Access Compliance Report

Public Rights-of-Way

Intersection ID: N/A	Main Street: STEEL_CREEK_RD	Cross Street: SHOPTON_RD	Location: N
ADA ID: 99A6FA561819	Ramp Type: Perp	Initial Pass/Fail: Fail	Overall Compliance: No
Severity Score: 13.75			
Codes/Mitigation Info/Possible Solution		Field Measurements/Component Compliance

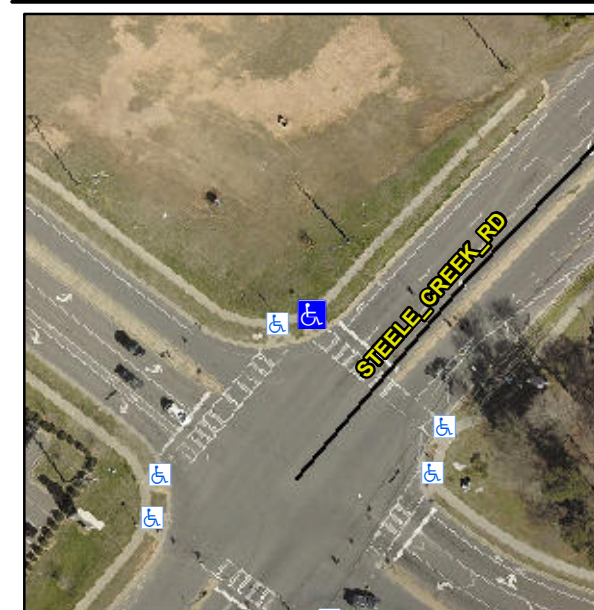
Not Found, R304.2.2, R304.5.3

Compliance	Description	Data	Compliance	Description	Data
N/A	Ramp Length (in)	96.0	No	Ramp Slope (%)	9.5
Yes	Ramp Width (in)	48.0	No	Ramp XSlope (%)	2.9
N/A	Flare Type LT	N/A	N/A	Flare Type RT	N/A
N/A	Flare Slope LT (%)	N/A	N/A	Flare Slope RT (%)	N/A
N/A	Flare Traversable LT?	N/A	N/A	Flare Traversable RT?	N/A
N/A	Landing Length (in)	N/A	N/A	DWS Provided?	N/A
N/A	Landing Width (in)	N/A	N/A	DWS Contrast?	N/A
N/A	Landing Slope (%)	N/A	N/A	DWS Length (in)	N/A
N/A	Landing X Slope (%)	N/A	N/A	DWS Full Width?	N/A
N/A	Landing Curb? (Y/N)	N/A	N/A	DWS Offset (in)	N/A
N/A	Shared Landing?	N/A			
N/A	Gutter Ponding?	N/A	N/A	Gutter Slope (%)	N/A
N/A	Gutter Lip Ht (in)	N/A	N/A	Gutter X Slope (%)	N/A
N/A	Painted X Walk1?	Yes	N/A	Painted X Walk2?	N/A
	X Walk 1 Direction	To SE		X Walk 2 Direction	N/A
N/A	X Walk 1 Width (in)	112.0	N/A	X Walk 2 Width (in)	N/A
	X Walk 1 Slope (%)	6.4		X Walk 2 Slope (%)	N/A
	X Walk 1 X Slope (%)	0.7		X Walk 2 X Slope (%)	N/A

Remove & Replace Entire Ramp.
